RE: Painted Prairie Master Plan Amendment with Adjustments

**PAINTED PRAIRIE**

**TAB 10 - URBAN DESIGN STANDARDS**

#### TYPICAL LOT CONDITIONS WHERE SIDE AND FRONT YARDS ARE ADJACENT TO DEDICATED OPEN SPACE:

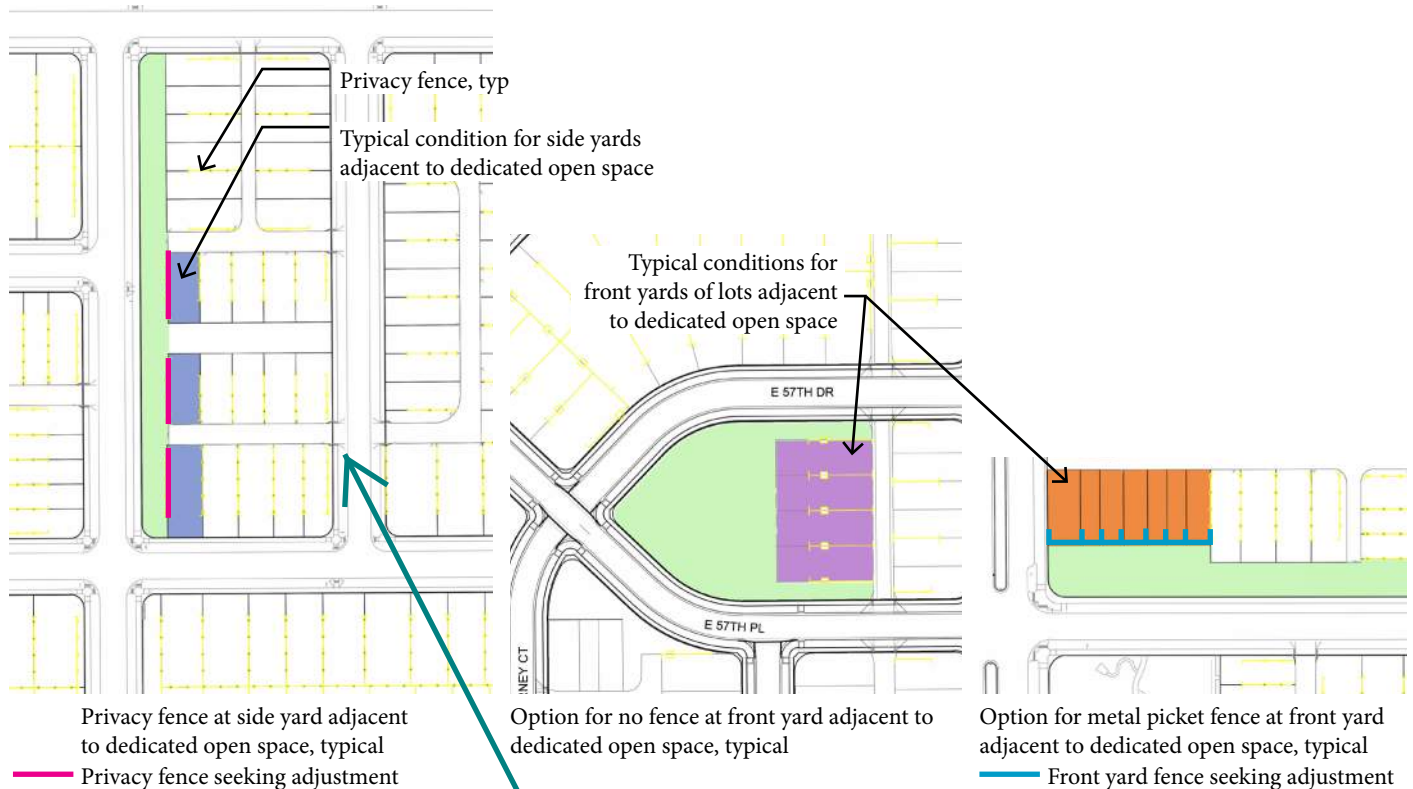
Is part of this drawing or image missing?

NO (?) ONLY SHOWING TYPICAL SIDE YARD CONDITION

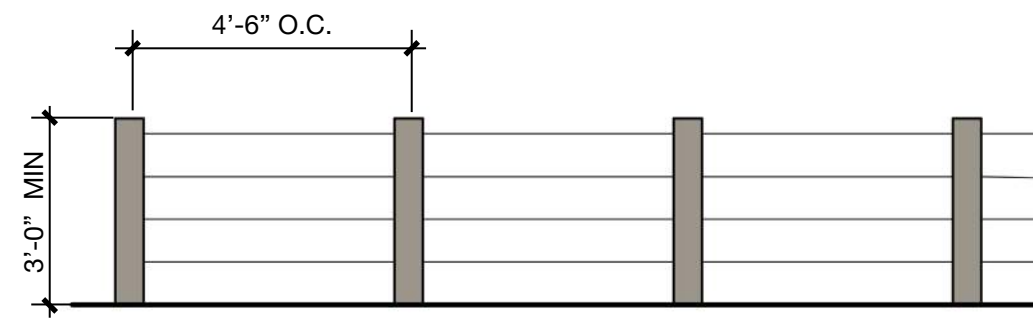
Identify material type for all proposed fences.

revised

Conceptual Section A-A  
Signature Fence  
at Lots Fronting Perimeter Street

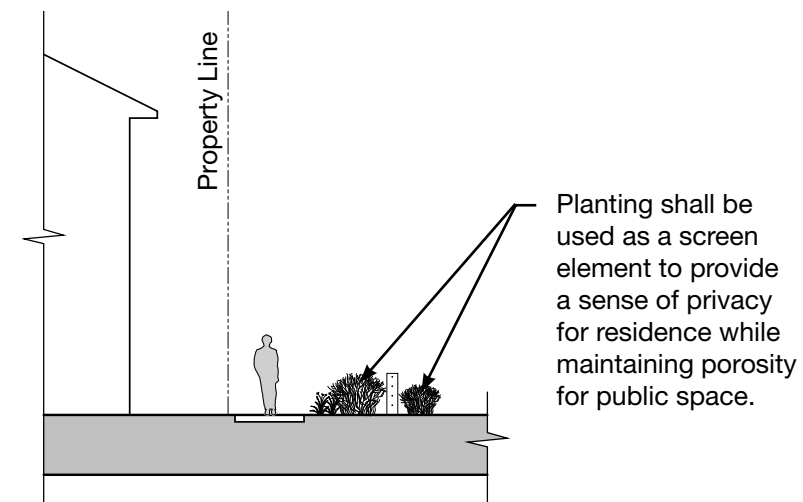
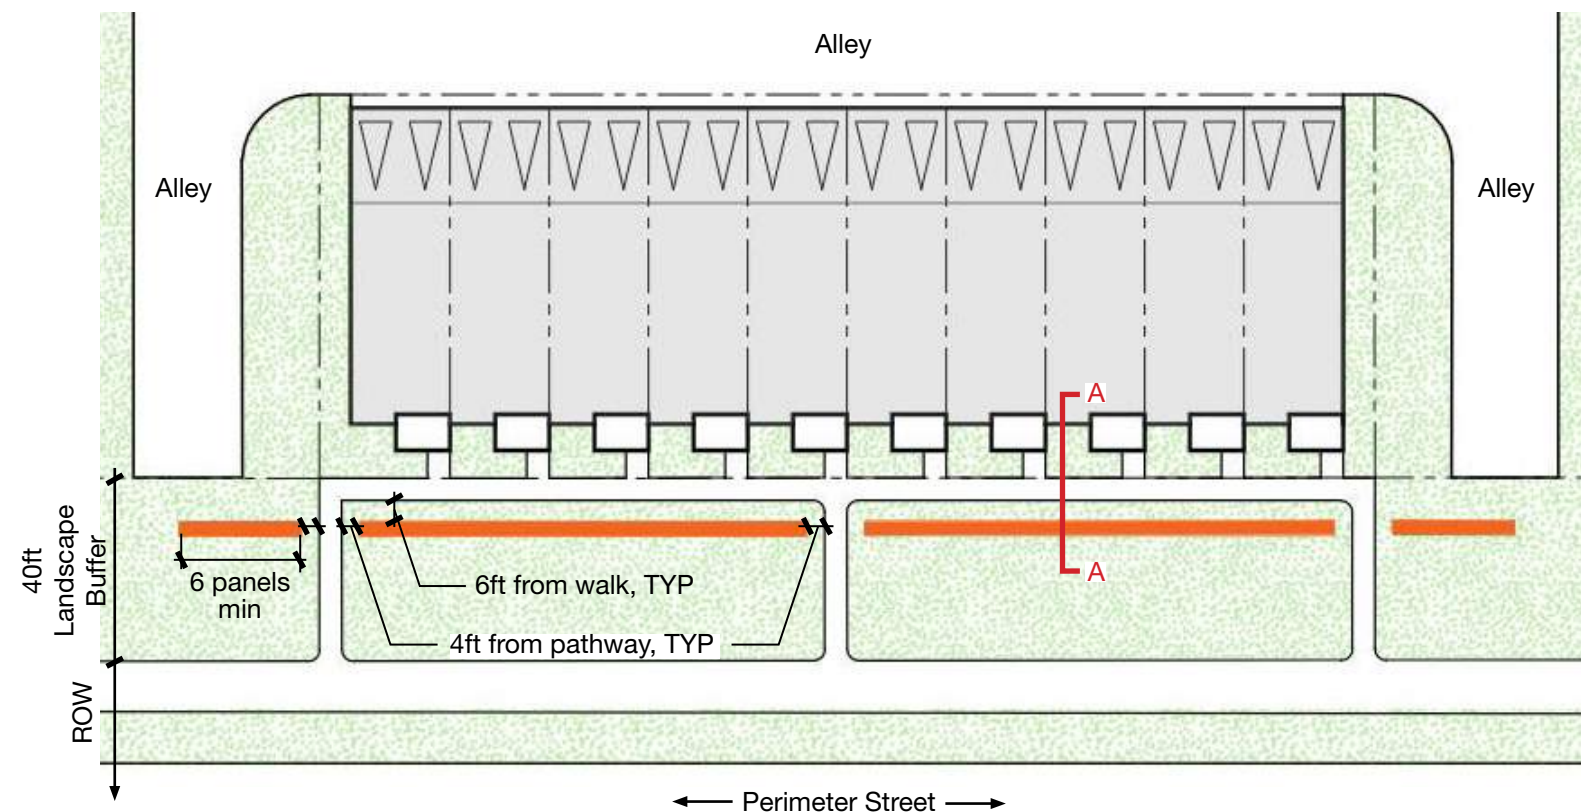
On the tour Chris expressed some dissatisfaction on the visual effect of steel wire. Want to confirm that this style and construction type will be used moving forward.

**CONFIRMED.  
ADDITIONAL  
PLANTING WILL  
ENHANCE. NO  
CHANGE NEEDED.**

Conceptual Plan Type 1  
5ft Privacy Fencing at Corner Lots

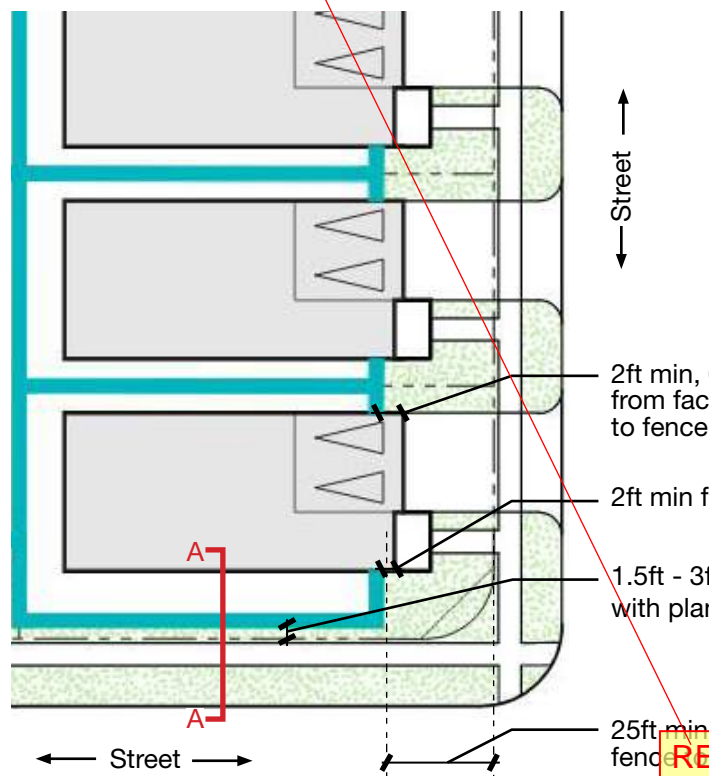
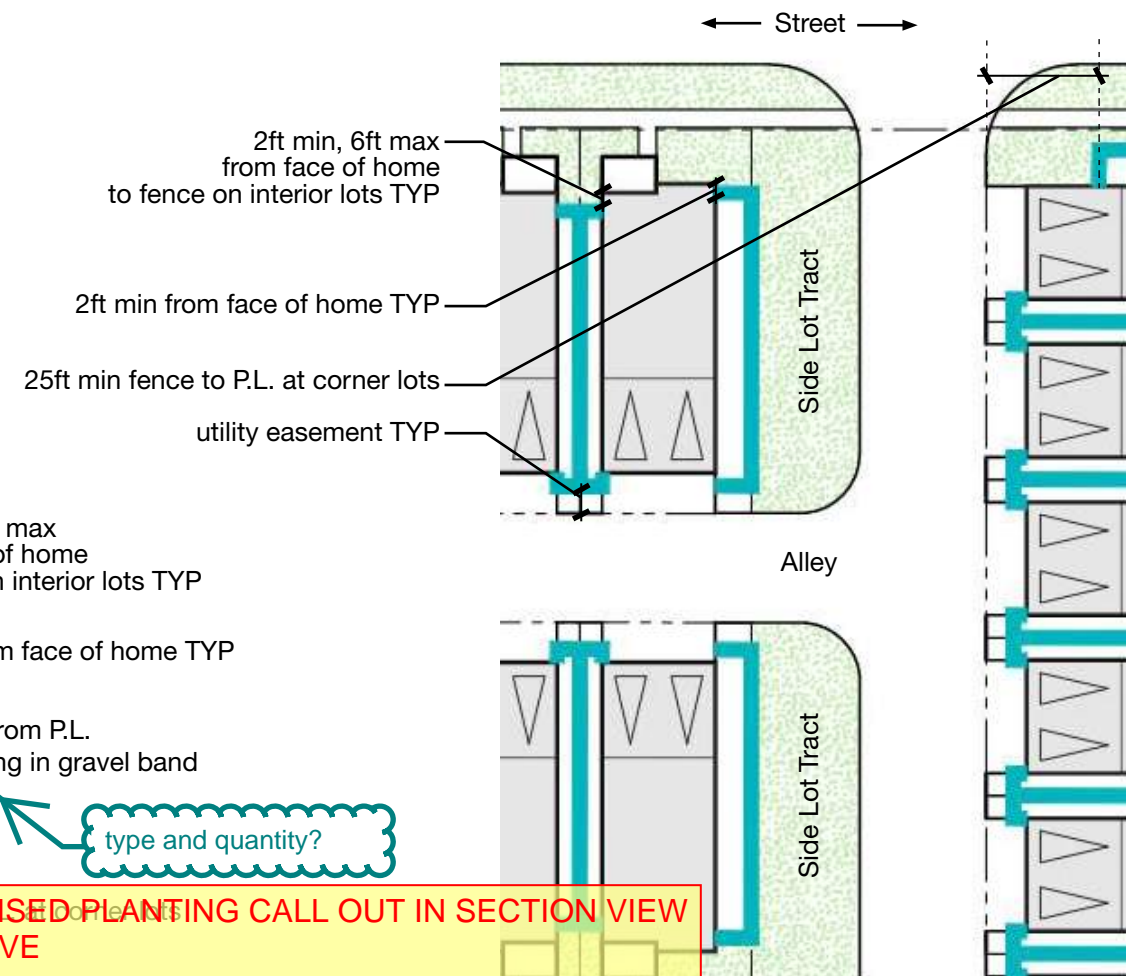
Also address the adjustment request here. Clearly identify that privacy fencing will be permitted along dedicated open space tracts.

**LANGUAGE REVISED**

Conceptual Plan Type 2  
5ft Privacy Fencing at Alleyways

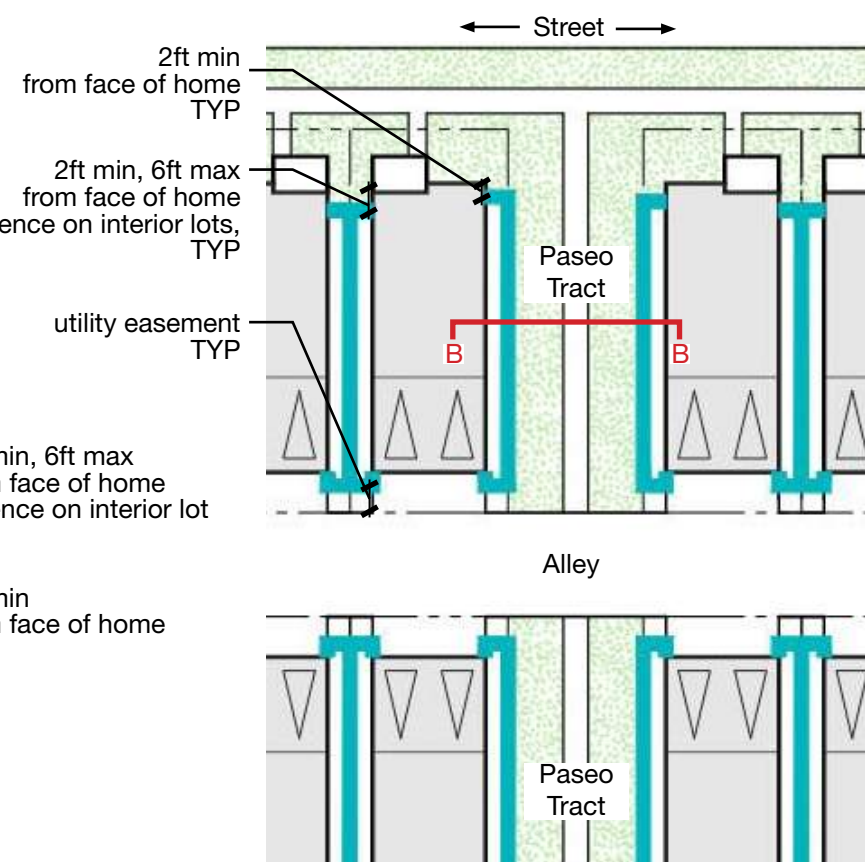
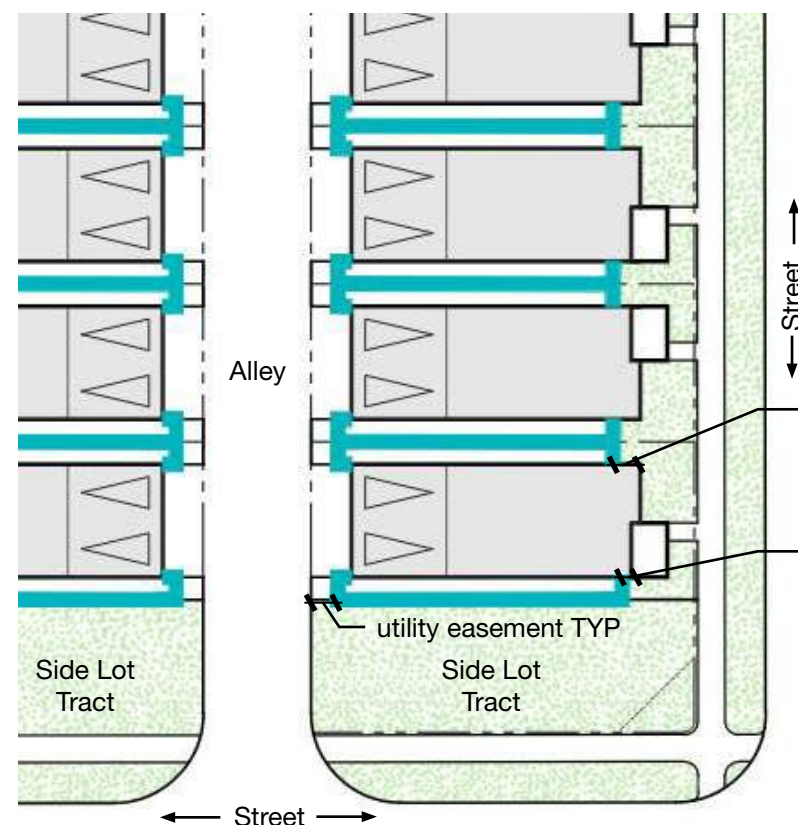
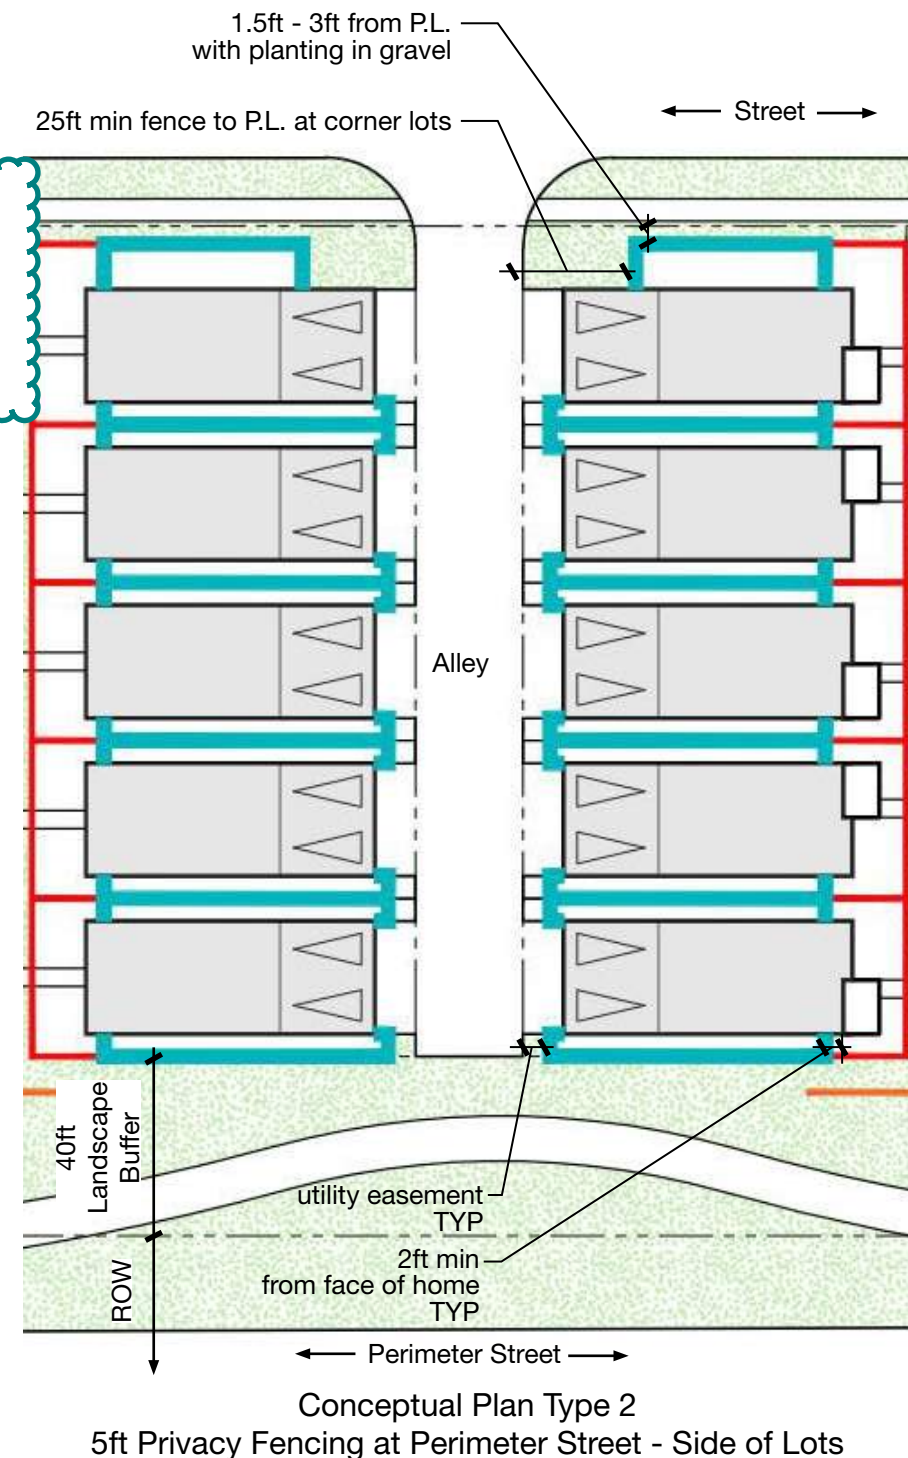
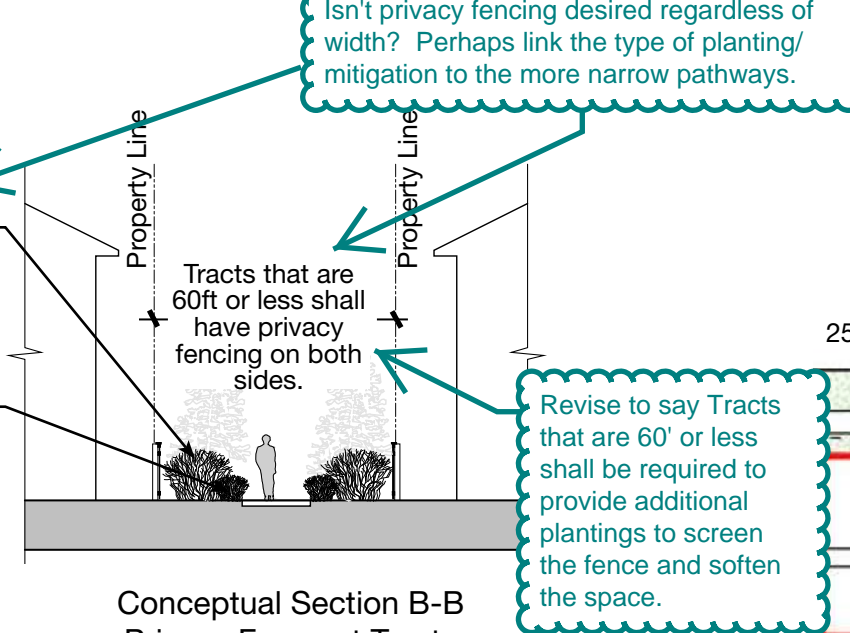
Specify a minimum  
quantity of shrubs.  
10/40 LF is a standard,  
the proposal should  
increase the amount to  
"mitigate" the  
adjustment request.

ALL CALLOUTS REVISED.  
PLANTING REQUIREMENT  
PROVIDED. 60' CRITERIA  
FOR PRIVACY FENCE  
REMOVED, AND PLANTING  
REQUIREMENT APPLIED  
TO IT AS ADJUSTMENT  
MITIGATION

## Discontinued Fencing

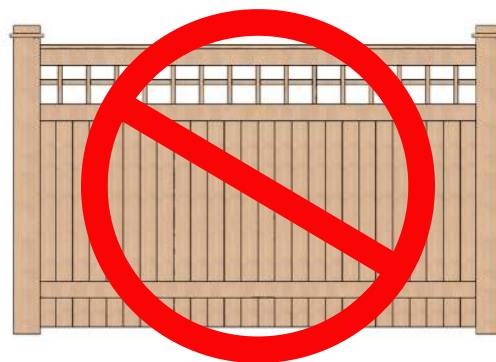
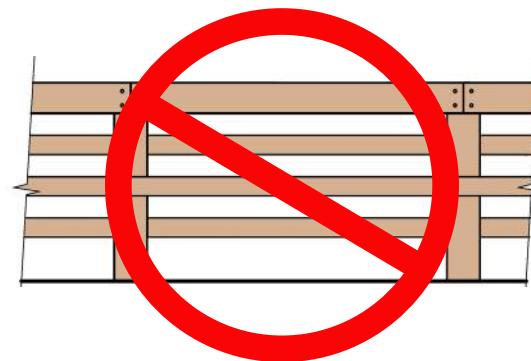
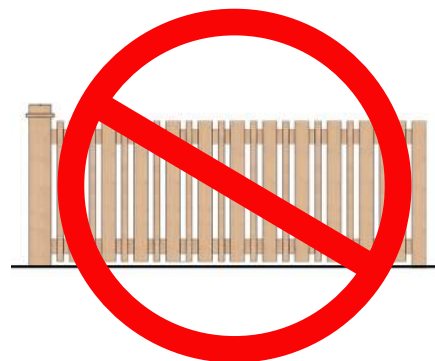
Leave allowance for fence repair? Do we really want to require fence changes on a house by house basis?

LANGUAGE REVISED TO ALLOW FOR REPAIRS.
